Informal document No. **GRE-67-27**
(67th GRE, 26-29 March 2012,
agenda item 4(c)(i))

Comments on GRE/2012/21 (Lighting & Signalling WG)

Headlamp Initial Aiming

- **Warning message**

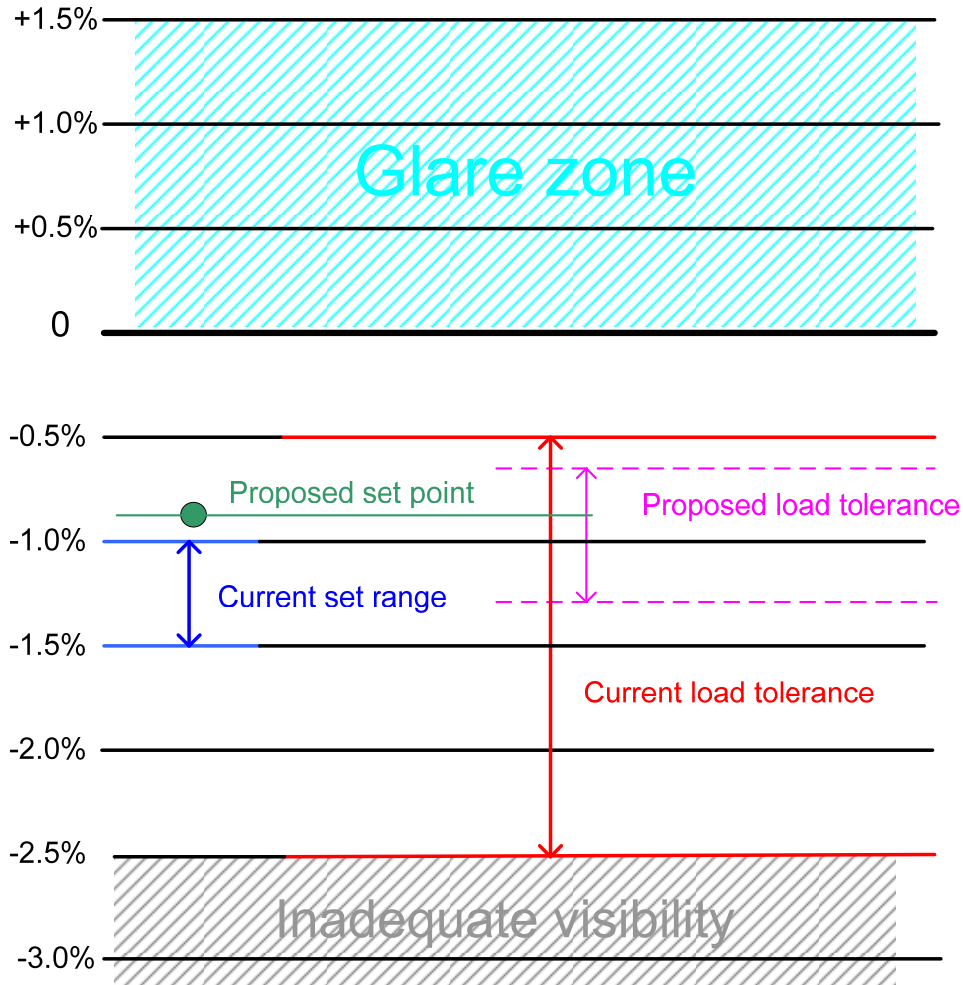
- While it is clearly advantageous that the driver is aware of the potential limits of visibility of headlighting systems, we do not believe R48 Type Approval is the appropriate place for this.
- The responsibility rests with the driver to judge what his visibility distance is in any circumstances; any information we give him must assist his decision, not make that decision for him.
